# Lamps V2.0 Proposal Discussion (4 of 4)

**November 23, 2015**

Taylor Jantz-Sell LC, U.S. Environmental Protection Agency

## Rated Life (proposed)

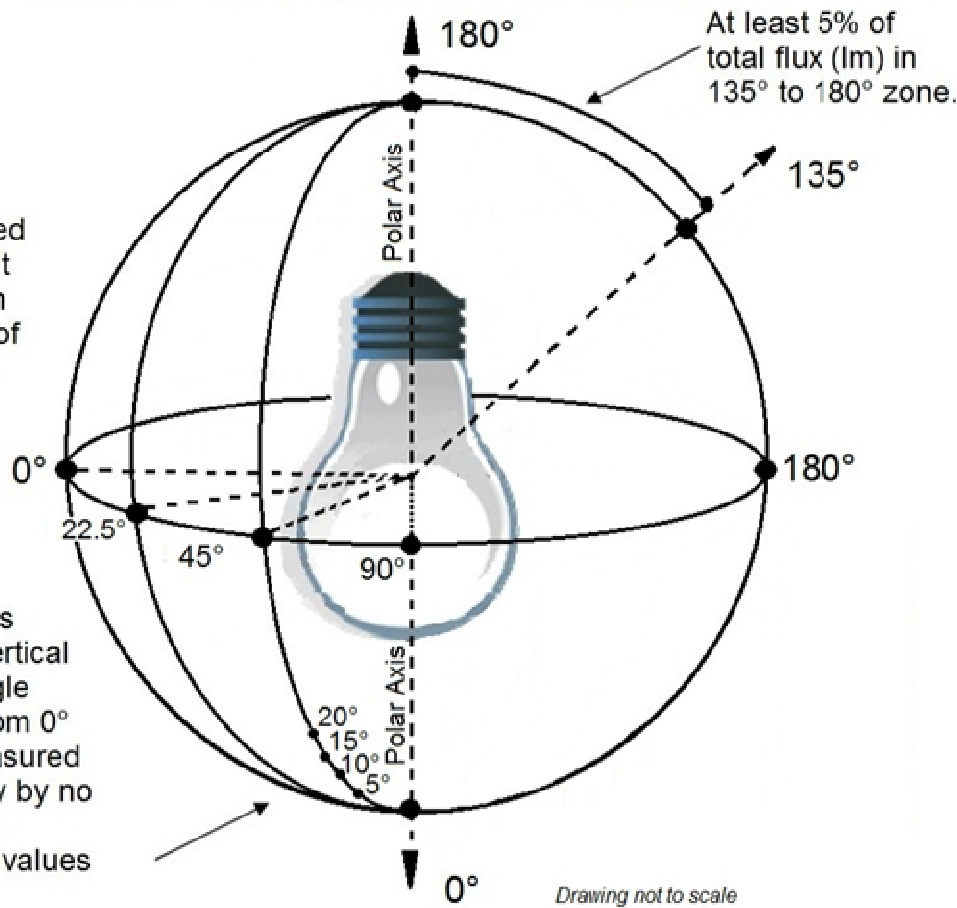
- Support was shared by multiple stakeholders for the proposed 15,000 hour life requirement for Omnidirectional lamps
- One manufacturer suggested EPA consider a 15,000 for directional lamps as well (for residential customers)
- Several efficiency advocates suggested EPA maintain 25,000 hour life requirement for directional lamps
- Testing would be the same as for decorative lamps, 86.7% lumen maintenance at 6,000 hours (93.1% at 3,000 hours for initial cert)

- A manufacturer was opposed to the decrease in omnidirectional rated lifetime from 25,000 to 15,000 hours.

- Four utility and efficiency program stakeholders opposed the omnidirectional LED lifetime proposal of 15,000 hours.
- A manufacturer partner and a utility representative supported EPA's lifetime proposal

EPA is proposing a rated life requirement of 15,000 hours for all LED omnidirectional lamps

- This matches the current requirement for decorative LED lamps.
- Based on the FTC reporting requirements, this equates to 13.7 years based on 3-hour/day operation.
- At the same time EPA is proposing to tighten the requirements for passing the life and lumen maintenance test by requiring that all units (versus the current 9 of 10) be operational throughout the duration of life testing.

# Omnidirectionality (proposed)

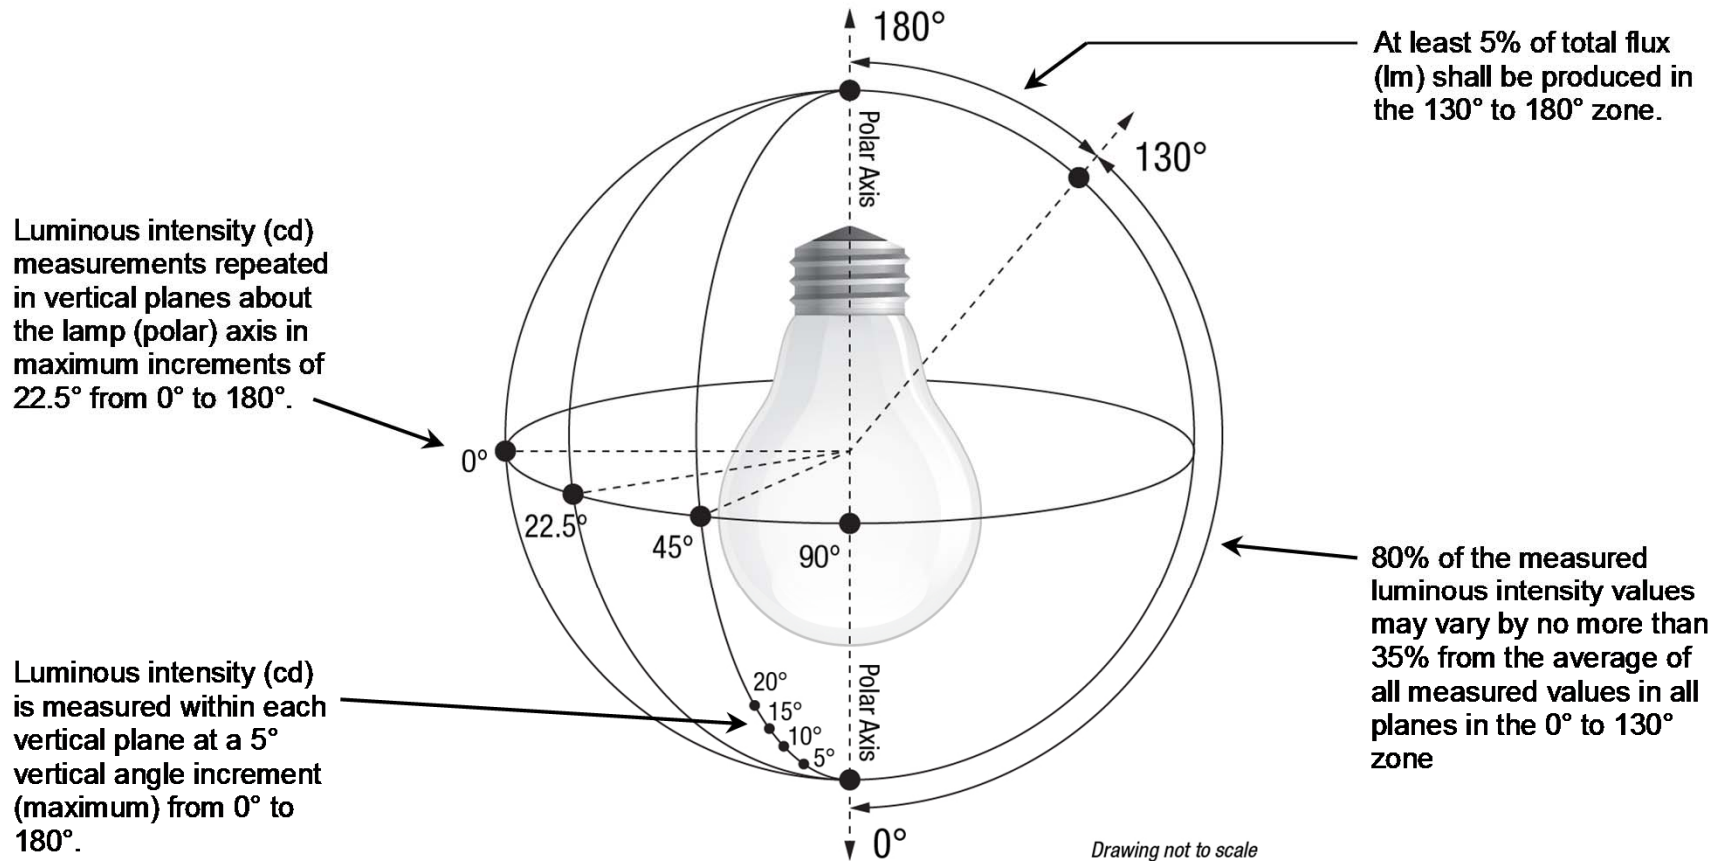
- One manufacturer expressed concern that the proposed change was not as generous as they had hoped but has since submitted written comments in support of this proposal.

- One efficiency advocate supported the modest adjustment in omnidirectional requirements and expressed her concern that it should not be adjusted further.

- A manufacturing partner and an efficiency organization representative expressed support for the changes to the omnidirectionality requirements.

## Efficacy (continued)

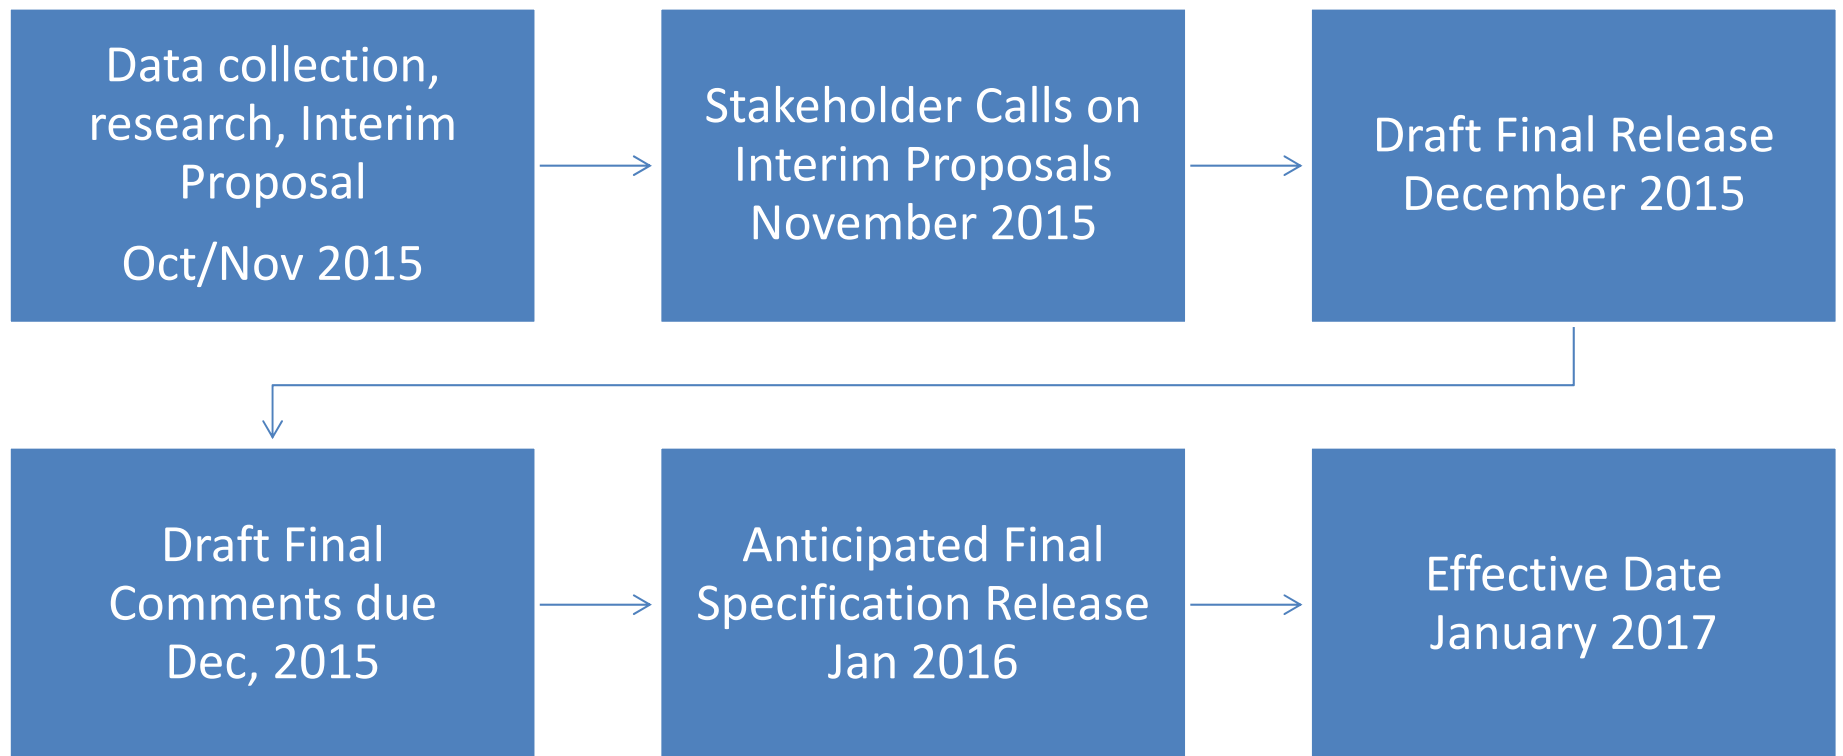
- One efficiency advocate expressed concern about 61 LPW requirement for directional lamps with CRI  $\geq 90$
- EPA explained that the level would allow for the specification to accommodate a wide range of performance for these products that would be necessary to accommodate a variety of markets and customers.

- One program implementation stakeholder suggested that the efficacy levels in the proposal were too high and that preventing cost effective CFL programs will severely hinder the ability of some utilities to meet their goals.
- A manufacturer suggested that efficacy levels were appropriate and that LED bulb prices are dropping to a cost effective point and that they offer more value than CFLs so they don't have to be as cheap.

- A manufacturing partner suggested lowering the efficacy requirement range from 65-80 to 65-75.
- A manufacturing partner and an efficiency organization representative supported the proposed efficacy levels.

**Question:** is there additional information EPA should consider on this issue?
